**Subject: PowerGrip® Kit K015563XS**

Technical Bulletin

## Installation recommendations for timing system on GM/Isuzu engines Y17DT, Y17DTL and Z17DTH using K015563XS

Fig. 1a  
OE ref. 5636724

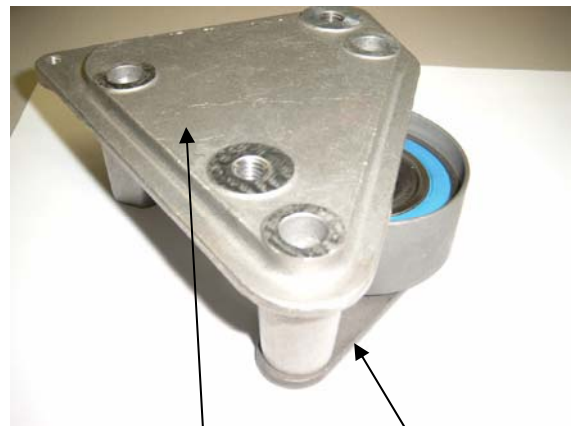
The coil spring tensioner is also used as an upgrade of the old tensioner (OE ref. 5636724 – fig.1a) which is no longer available at OES level.

For these engines (until engine number 328704), however, there is a problem to install the new tensioner along with the existing engine support bracket.

Fig.1b shows how the base plate of the old tensioner is placed under the bottom leg of the engine support bracket. The new tensioner does not have such a base plate.

To replace an old type tensioner with the new coil spring one, one needs to replace the engine support bracket as the bottom leg now has to be just as long as the other two. Additionally, a stud (OE ref. 5636706 - Fig.2 b) has to be inserted to attach the coil spring of the new tensioner.

So we need to adjust the components of our kit to also cover the older vehicles. But as the new support bracket (OE ref. 5684110) is quite expensive, we have decided to offer one efficient low cost replacement solution for all engines. We will do this by including a high grade stainless steel spacer (Fig. 3), with the same thickness as the base plate of the original tensioner, to overcome the length difference in the legs of the engine bracket.
